**IN THE UNITED STATES COURT OF APPEALS  
FOR THE EIGHTH CIRCUIT**

**PETITION FOR REVIEW**

#### Approval and Promulgation of Implementation Plans; North Dakota; Regional Haze State Implementation Plan; Federal Implementation Plan for Interstate Transport of Pollution Affecting Visibility and Regional Haze

Figure 1. Coal-Fired Boilers Operating Below 0.17 lb/MMBtu

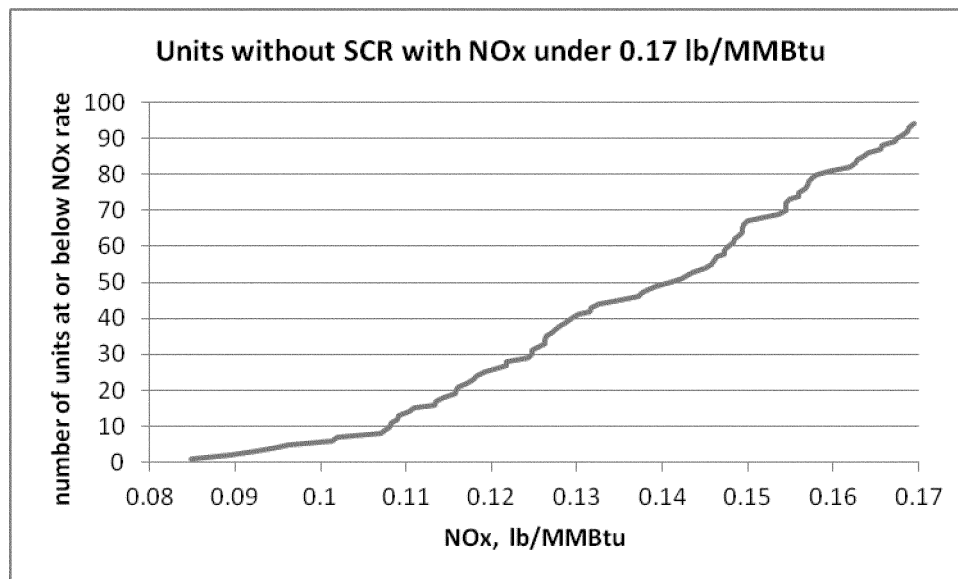
Analysis of emissions data found significant discrepancies in Figures 2.2 and 2.3 of GRE's November 2011 Refined Analysis. A review of EPA Title IV data for 2010 showed 94 coal-fired boilers that do not have SCR achieve annual emissions levels below 0.17 lb/MMBtu, with the median slightly under 0.14 lb/MMBtu (see Figure 1 below). Of these, ten of them are using SNCR in combination with combustion controls to achieve under 0.17 lb/MMBtu. See docket for a list of these facilities. Of these ten, three are supercritical tangentially-fired boilers that use lignite coal with emissions below 0.14 lb/MMBtu. These include Big Brown 1 and Monticello 1 and 2, as discussed earlier in our responses. In addition, the NEEDS Database v.4.10 for the Final Transport Rule in the CSAPR docket includes two tangentially-fired coal/steam units from North Carolina with LNC3 and SNCR that had emission rates of 0.159 lb/MMBtu and 0.164 lb/MMBtu.

As we explain elsewhere, we have decided to revise the BART limit from 0.12 lb/MMBtu to 0.13 lb/MMBtu on a 30-day rolling average.
